PLANNING DEPARTMENT – Development Review Services

**RE: Gold Avenue Casitas
Grading and Drainage Plan
Engineer's Stamp Date 10-1-2014 (File: K15D098)**

project title
GOLD AVENUE CASITAS
2109 GOLD AVE. SE
ALBUQUERQUE, NM 87106

sheet title
GRADING & DRAINAGE PLAN

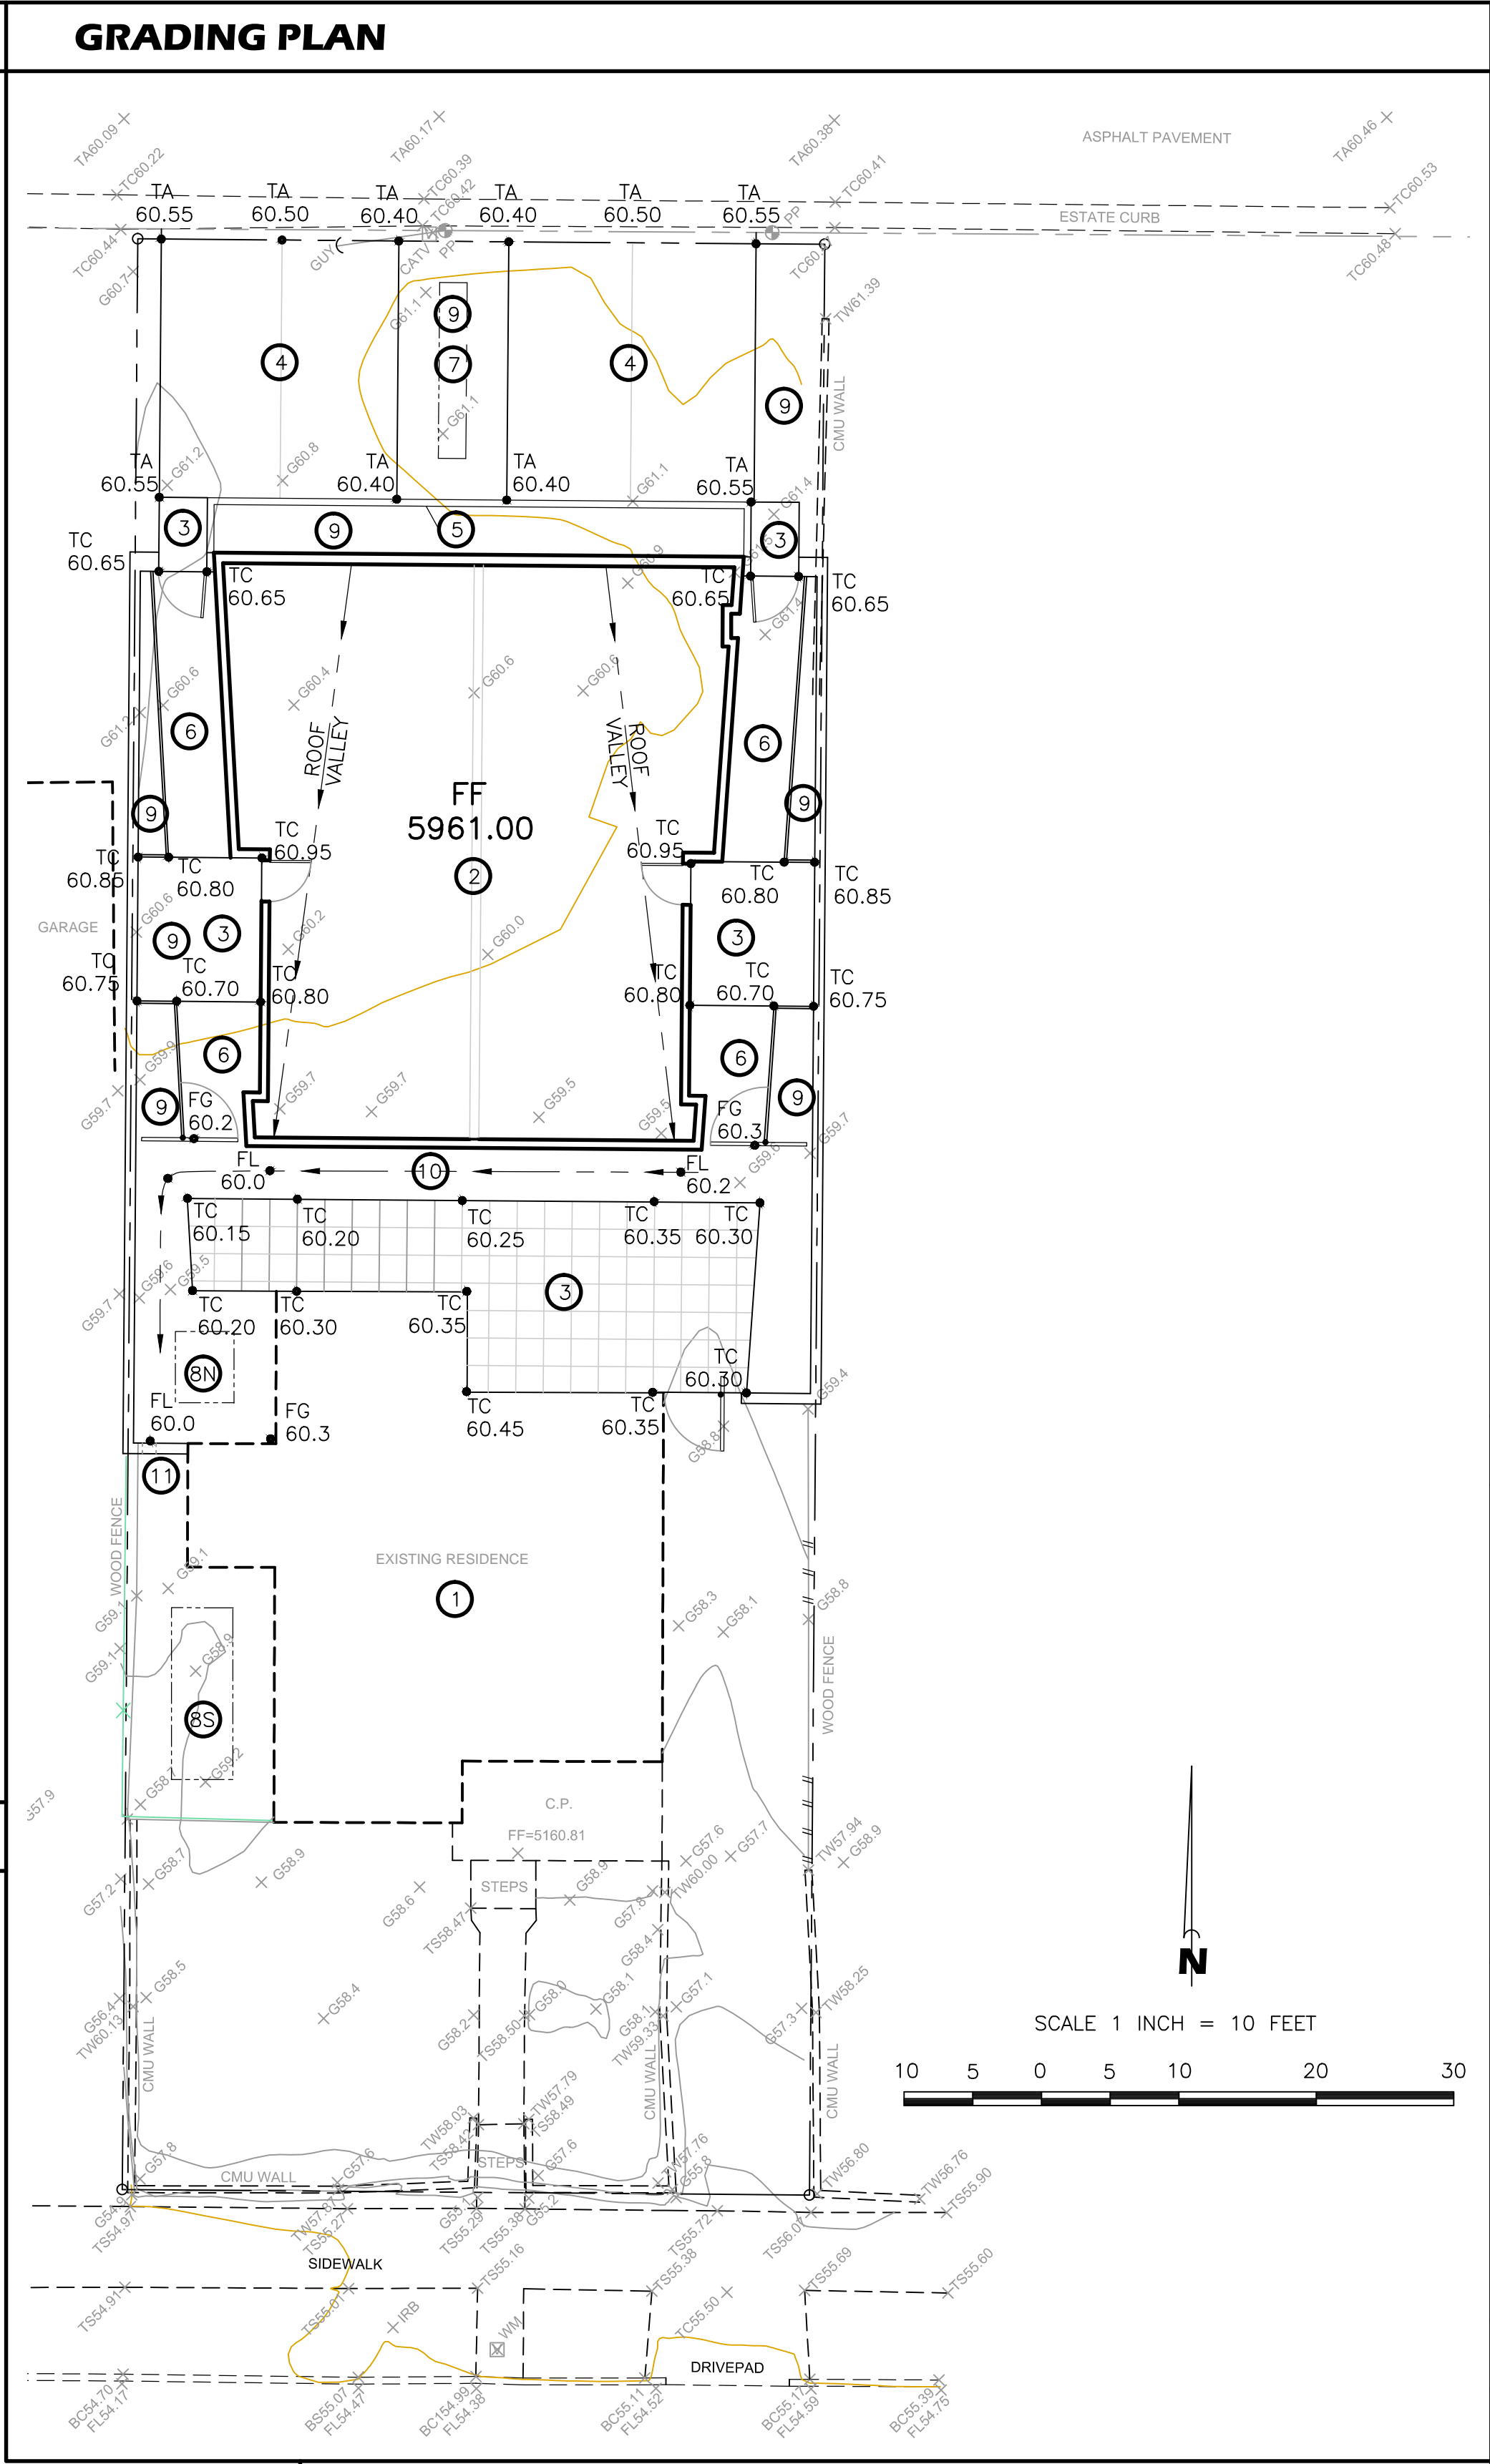
1. A drainage swale needs to extend from the 8-South pond to the drivepad to allow rainfall in excess of the first flush to discharge to the street. The fence would be removed to allow for the flow.
